<b>Docket Number:</b>	08-AFC-08A
<b>Project Title:</b>	Hydrogen Energy Center Application for Certification Amendment
<b>TN #:</b>	202807
<b>Document Title:</b>	Environmental Justice in Wasco
<b>Description:</b>	A description of environmental justice issues associated with the expansion of the Savage coal facility in Wasco.
<b>Filer:</b>	Tom Frantz
<b>Organization:</b>	Association of Irritated Residents/ Tom Frantz
<b>Submitter Role:</b>	Intervenor
<b>Submission Date:</b>	7/25/2014 10:03:17 AM
<b>Docketed Date:</b>	7/25/2014

Re: 08-AFC-8A            Hydrogen Energy California

### **Environmental Justice and the Proposed Savage Coal Depot Expansion in Wasco**

## CalEnviroScreen 2.0 (draft) All Results Map

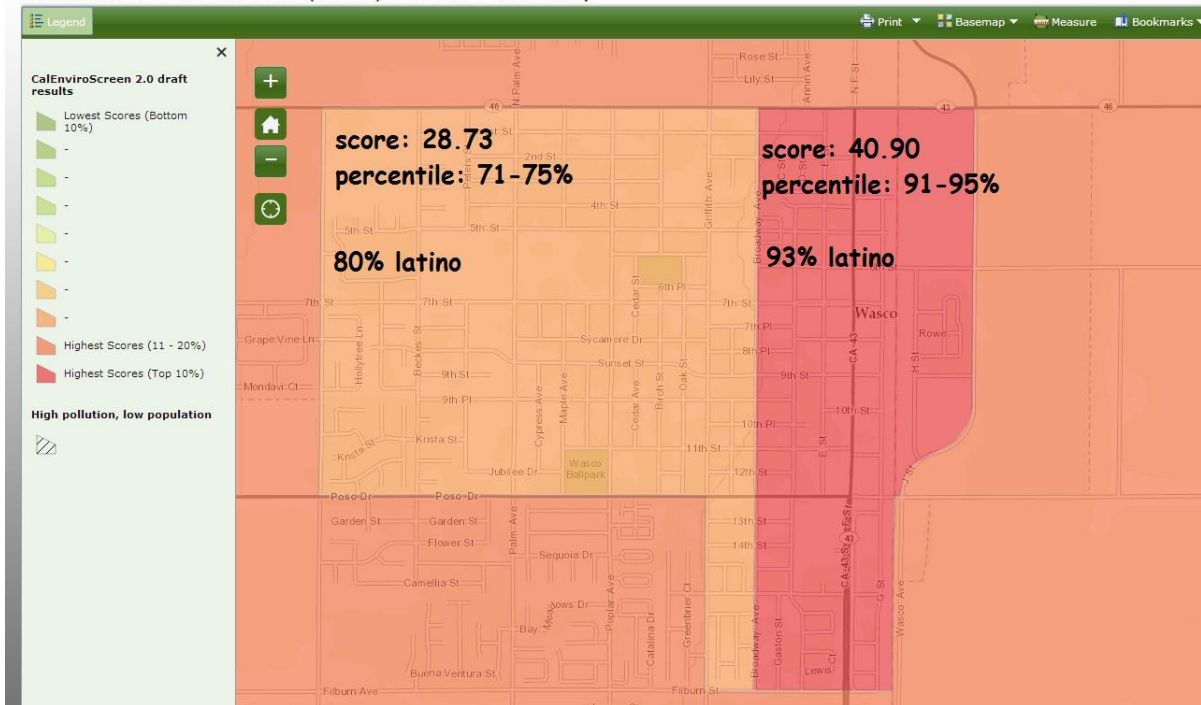
Below is a copy of the CalEnviroScreen map showing the City of Wasco and how it is divided in their assessment of environmental hazards. The west side of Wasco (75% of the town) is significantly less Latino and significantly lower in risk. The east side of Wasco is different. It has a population of around 5,000 people which is around 25% of Wasco's total population. It is clear that this east side of Wasco is a severely impacted environmental justice community.

The Farm Labor Camp is part of this environmental justice community and is the closest residential area to the Savage coal facility. The camp is located across the street to the north of Savage and runs along the east side of the railroad tracks with less than 300 feet of separation from the rails where coal carrying cars will be shuttled back and forth. Residents of the labor camp will be the most negatively affected from the environmental impacts resulting from expanded operations at the coal facility, however, the entire environmental justice community on this side of town will be exposed to greater risk as a result of this expansion. The CEC must analyze the increased cumulative risk from the proposed expanded operations at Savage on this area of Wasco designated by color on the map as among the highest risk areas in the state (top 10%).
